Case Numbers:
ZA-2020-752-ZAD-ZAA-1A
3005 North Amethyst St.

ZA-2020-781-ZAD-ZAA-1A
3009 North Amethyst St.

Appellant presentation for hearing
East Los Angeles Area Planning Commission
5/11/2022

The project as shown in case drawings on the department of planning website uploaded 6/30/2021 does not conform to the following key aspects of applicable zoning code/ordinances.

SHEET NUMBER:
A-0.4.0

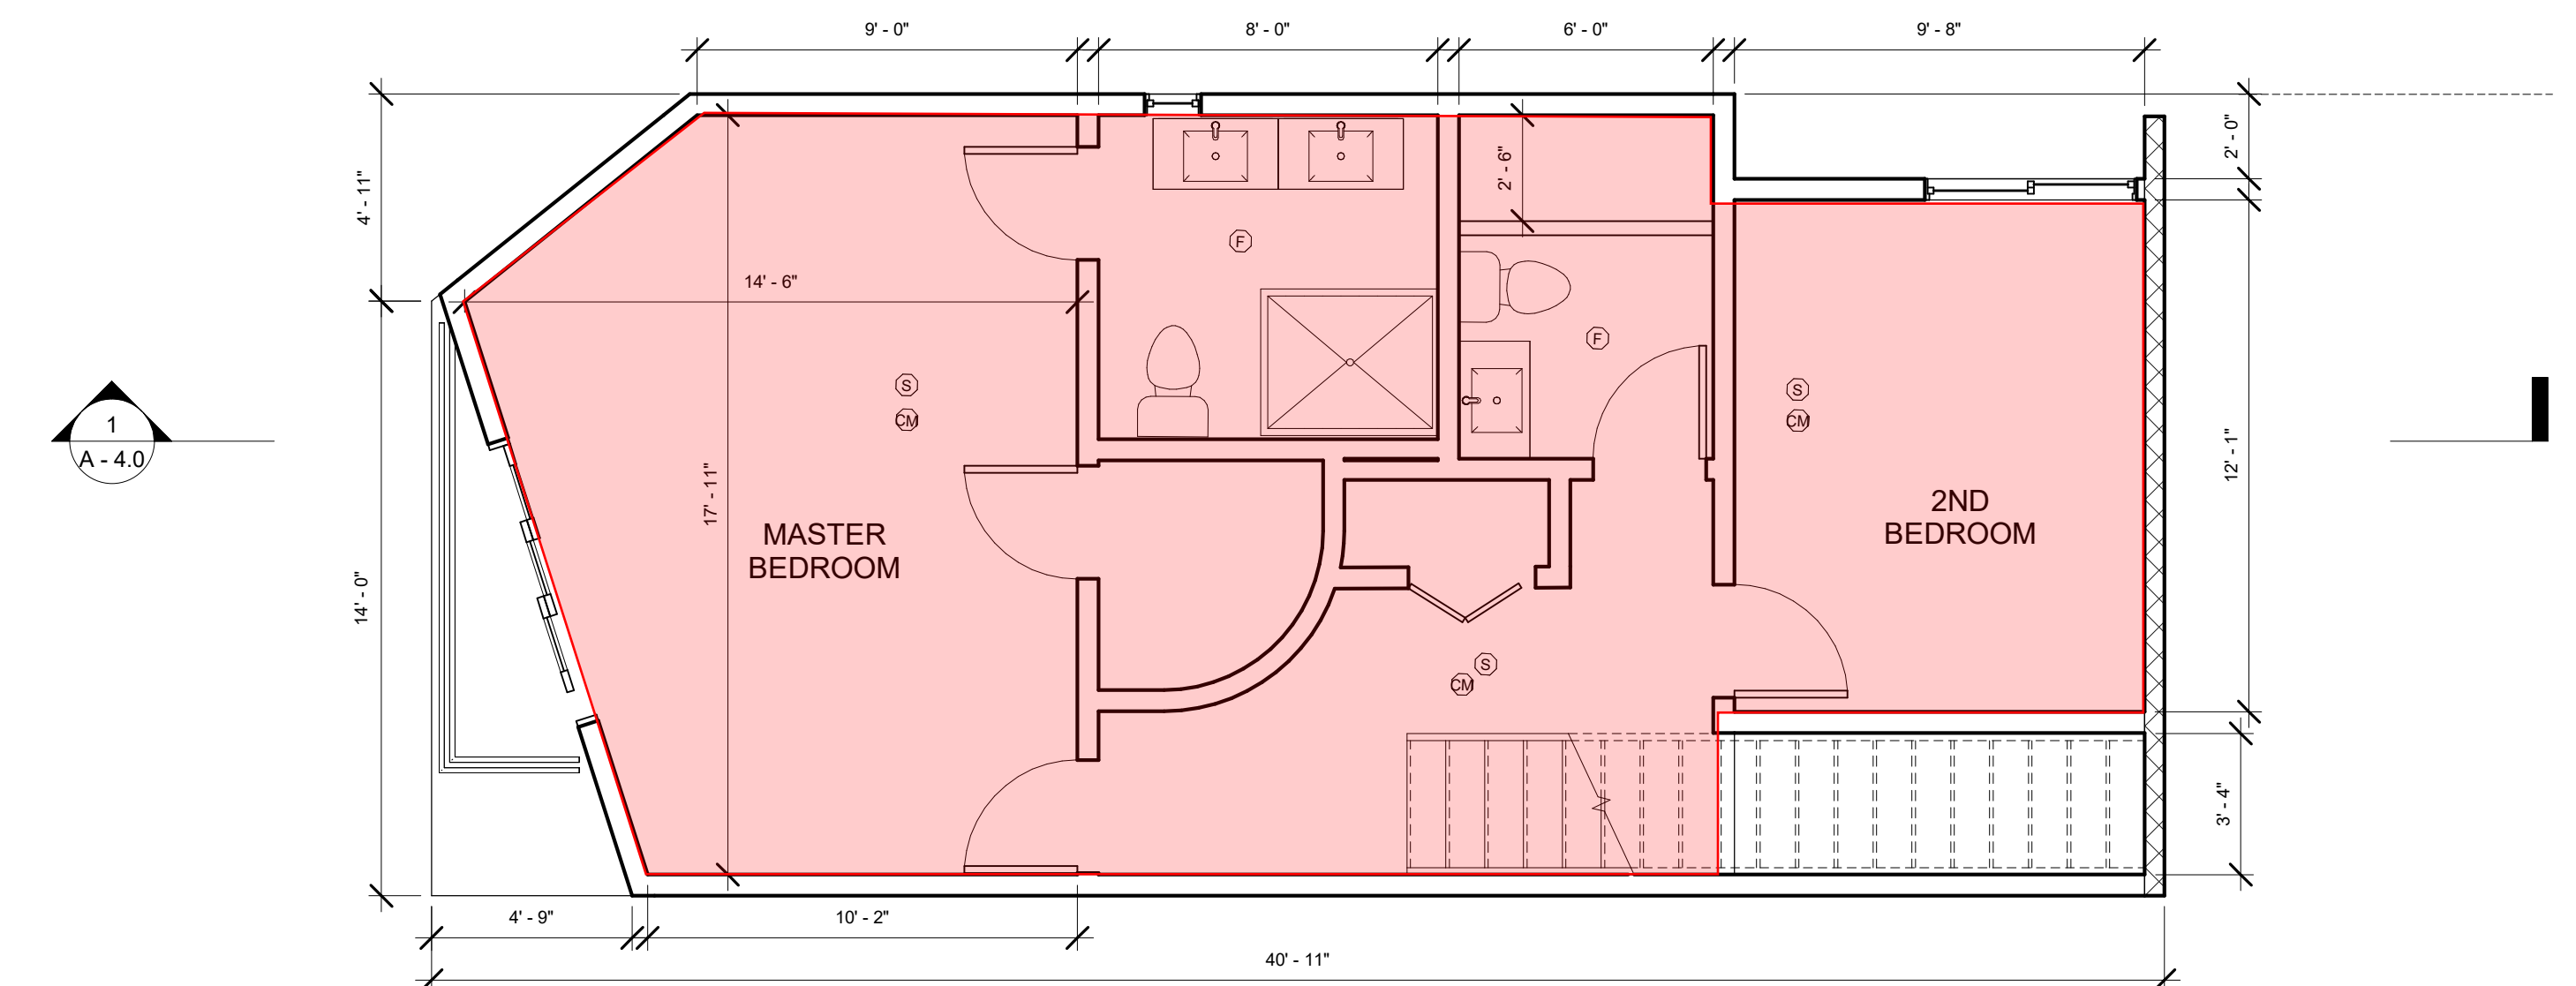
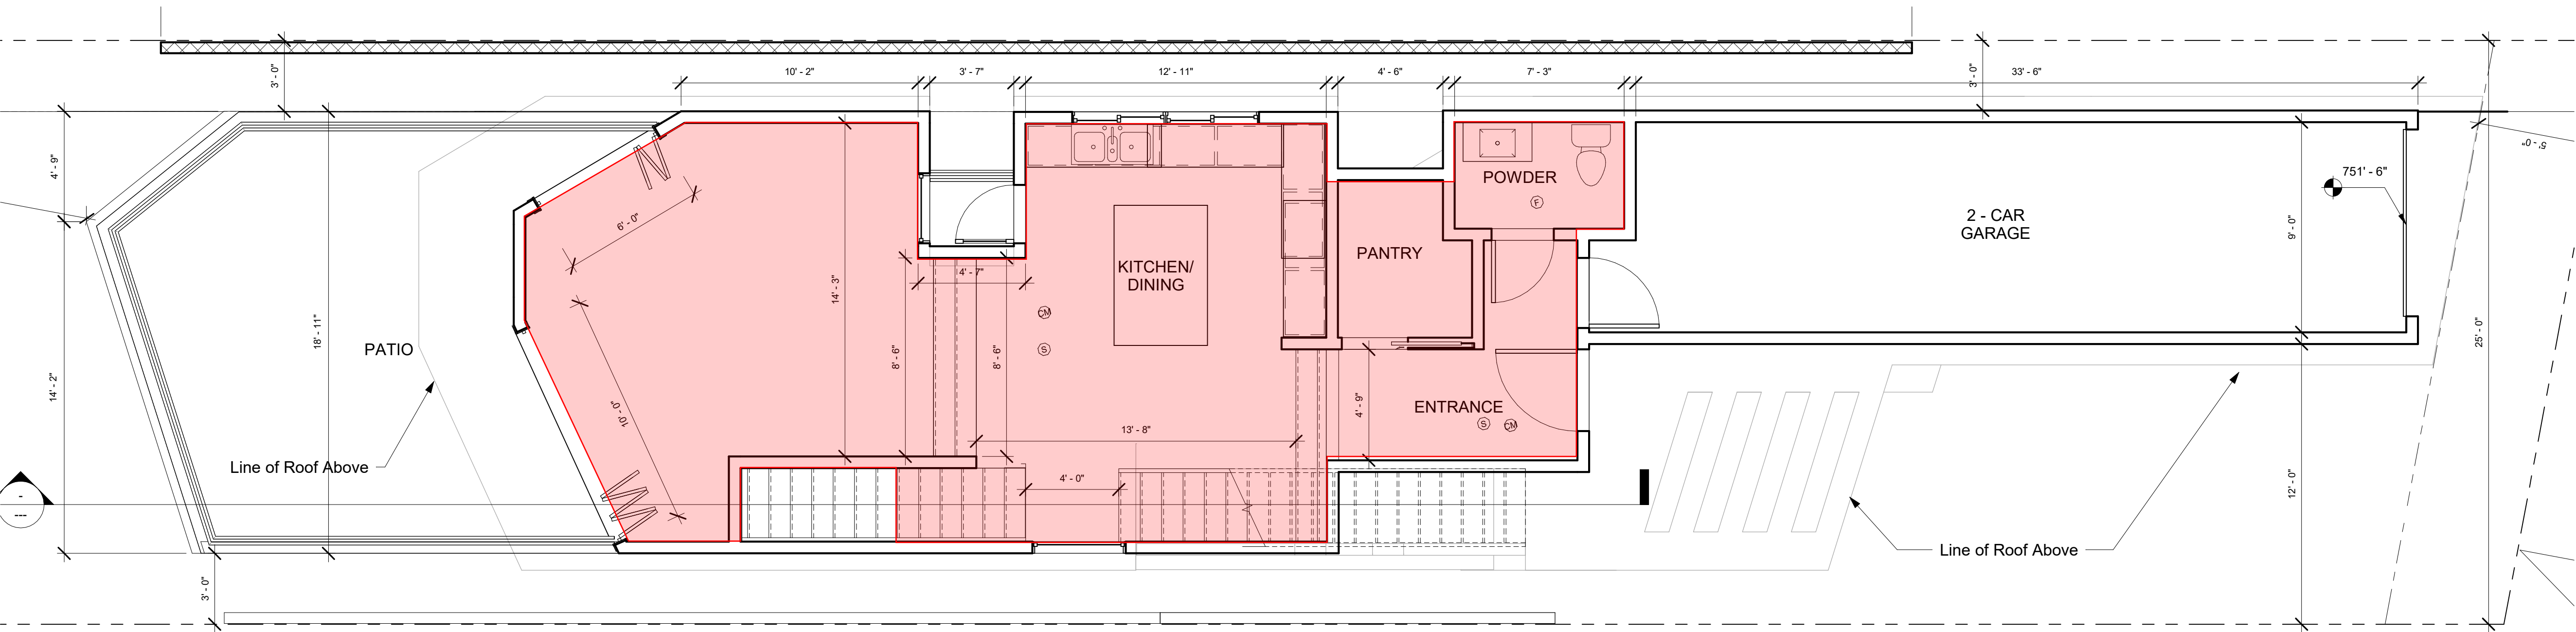
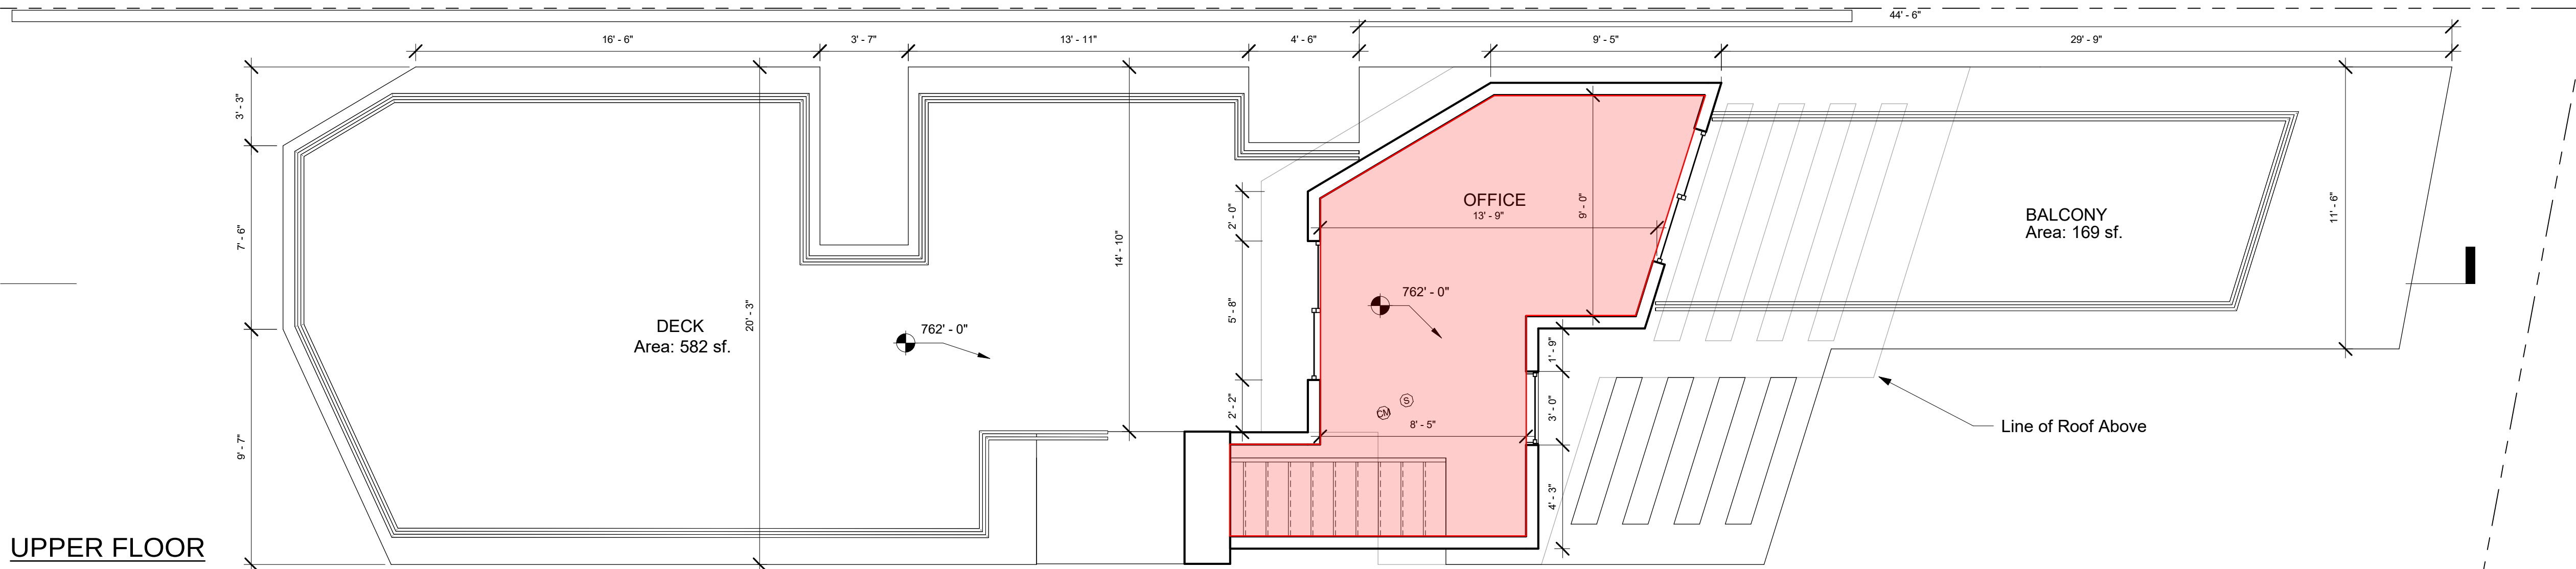
1. The project exceeds the height limitation contained within the Northeast Hillside Ordinance No.108403 Section A.2.e. by approximately 5'-6" (37%). The building height above the street level is 20'-6" and is required to not exceed 15' height within 50' of the ridgeline and 15' above the ridgeline beyond 50' distance. A review of the specific conditions in the building section profile, shows the building up to 8'-5" (56%) above the height limitation.

SHEET NUMBER:
A- 1.3.1

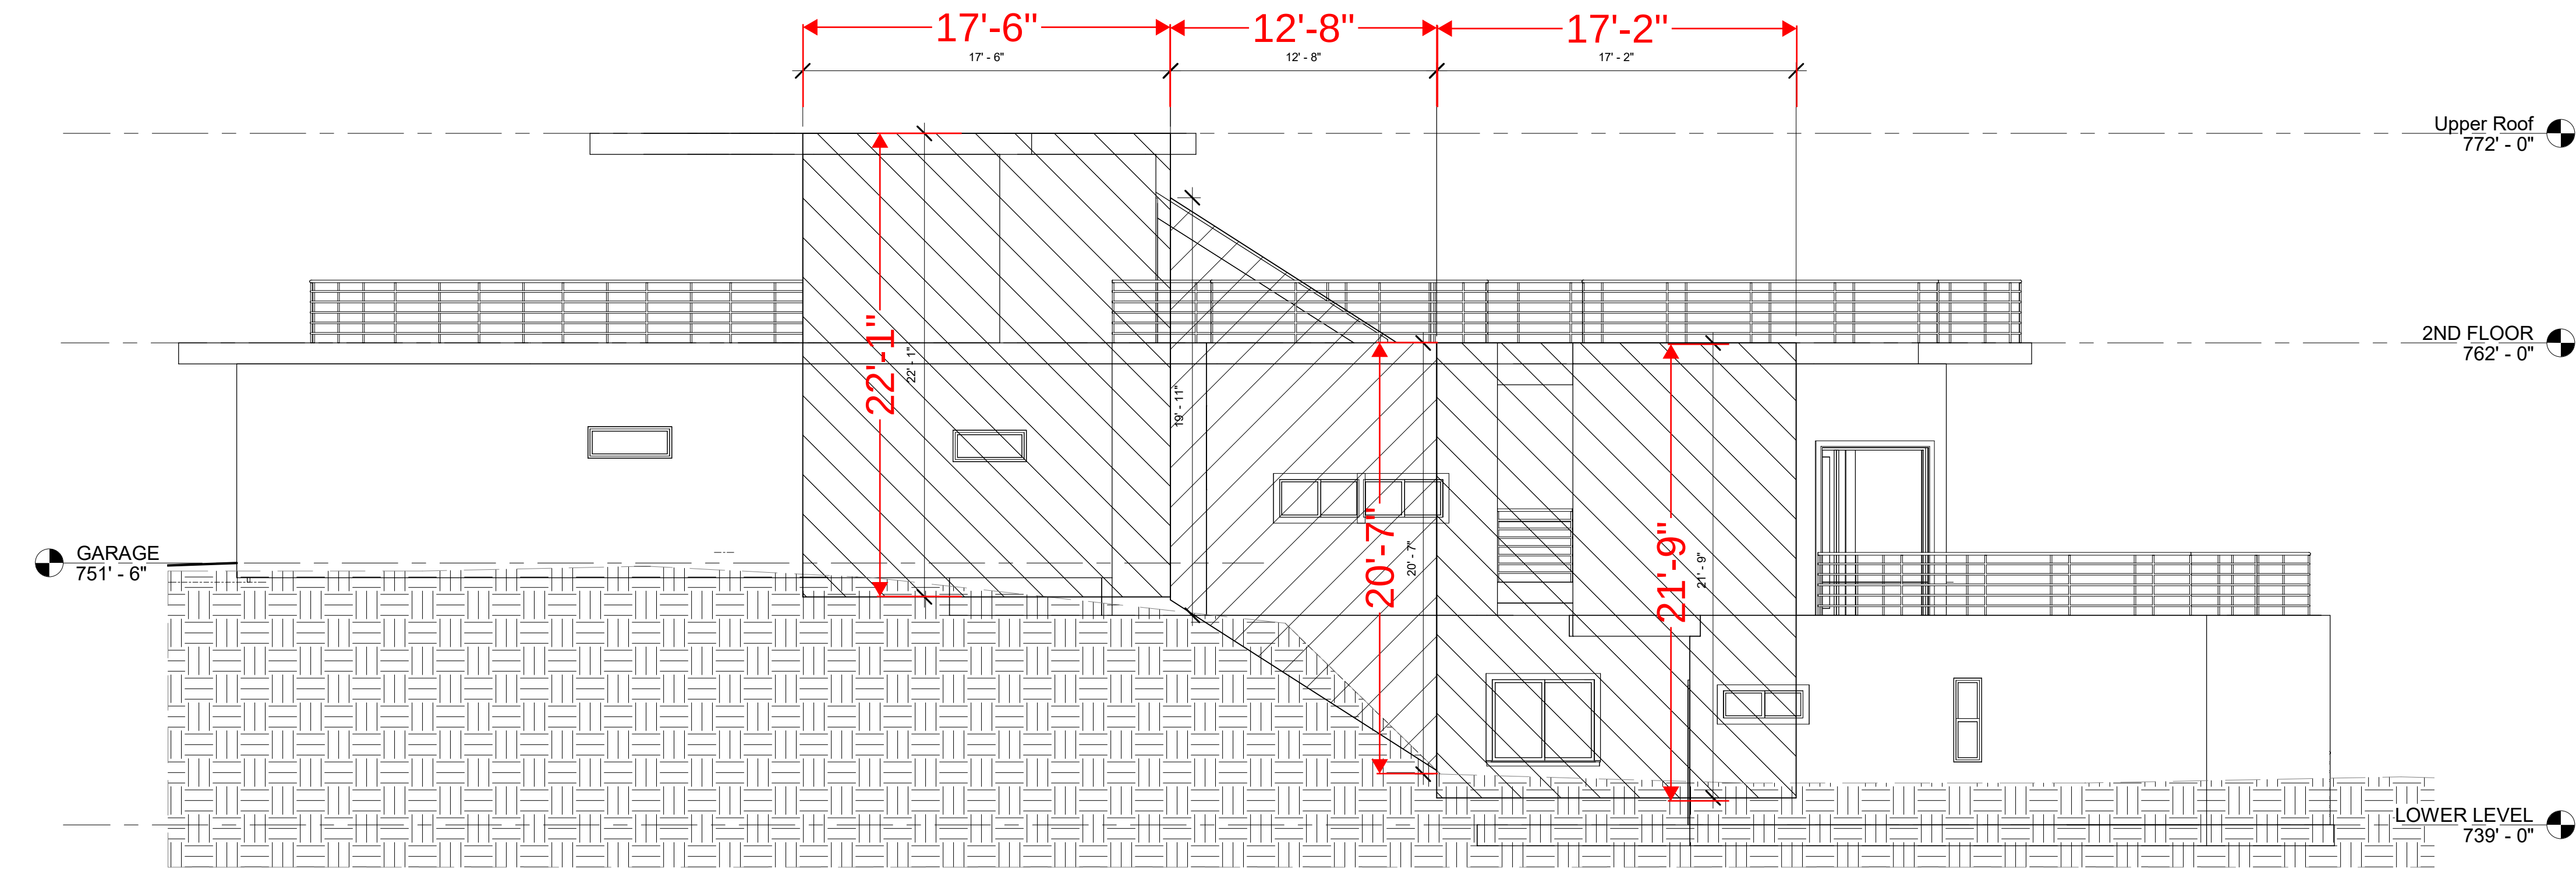
2. The project exceeds the maximum allowable Residential Floor Area per the Northeast Hillside Ordinance No.108403 Section 3.A.2 / LAMC 12.03 by approximately 194 sq ft / 13% (3005 Amethyst) and 244 ft2 / 18% (3009 Amethyst)
